Work Order ID 132450

Item Name: Quick Release Heli-Utility-Basket™ Long, HD Lid, Spacepod™/Squirrel Cheek Comp.

DART SERVICE INSTRUCTION

TO AMEND INSTALLATION INSTRUCTIONS D350-607-3 Rev.D,
INSTALLATION INSTRUCTIONS D350-607-4 Rev. C AND
INSTRUCTIONS FOR CONTINUED AIRWORTHINESS ICA-D350-607 REV. 6
REF TCCA STC: SH94-14
REF FAA STC: SR00213NY
REF EASA STC: EASA.10016996
REF BRAZILIAN STC: 2007S03-03/-04/-05/-06

FIGURE 1: INSTALLATION OF D4775-041 FWD STRUT

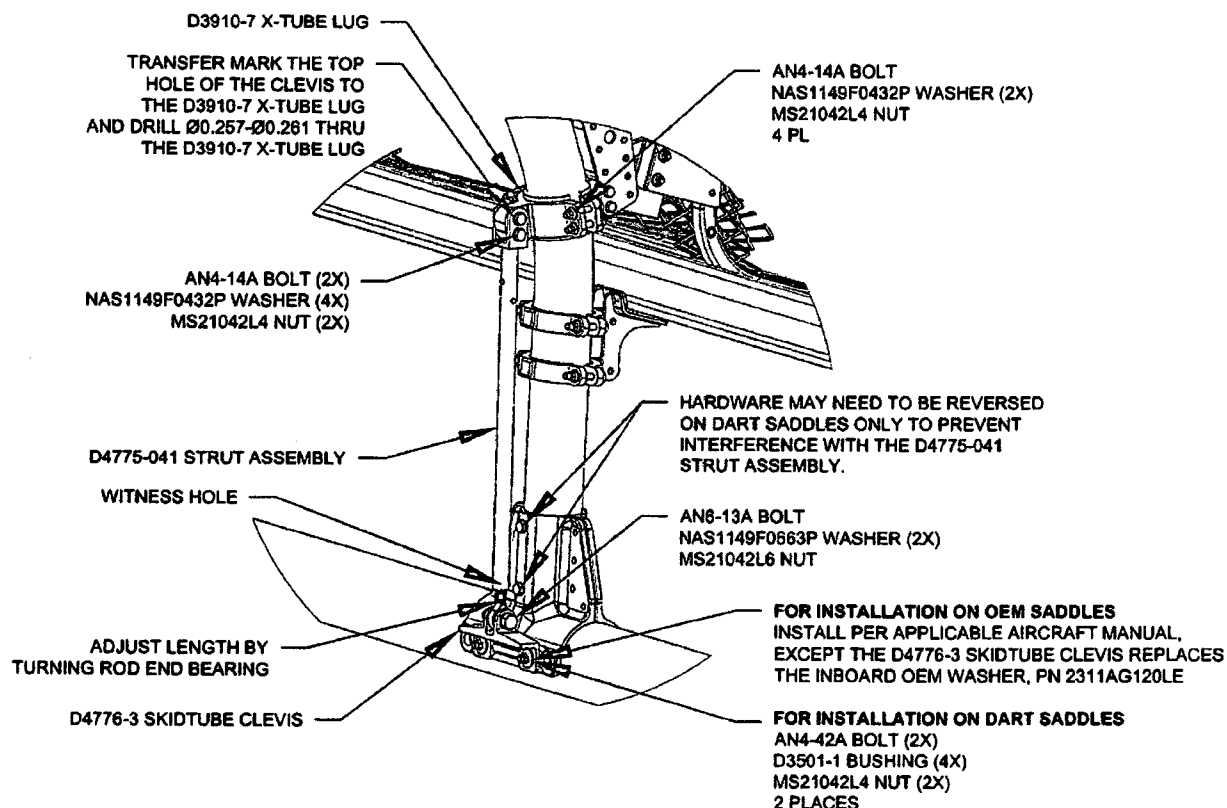
Modify the quantities for D3910-5 and add D3910-7 as follows:

- 3.1 Substitute the Forward Lower D3910-5 X-Tube Lug with the D3910-7 X-Tube Lug as shown in Figure 1.
- 3.2 Install the forward D4775-041 Strut Assembly. Transfer mark from the upper hole on the clevis of the D4775-041 Strut Assembly to the D3910-7 X-tube Lug and drill thru the lug $\varnothing 0.257$ - $\varnothing 0.261$ as shown in Figure 1. Touch up chemical conversion coating per MIL-DTL-5541. Check the witness holes located at the bottom end of the D4775-041 Strut Assemblies to ensure that the thread from the rod end extends past the witness hole.
Torque MS21042L4/-4 nuts to 50-70 in-lbs (5.7-7.9 N-m). Torque MS21042L6/-6 nuts to 160-190 in-lbs (18.1-21.5 N-m).
- 3.3 Complete the installation in accordance with Installation Instructions D350-607-3 Rev. D or D350-607-4 Rev. C.
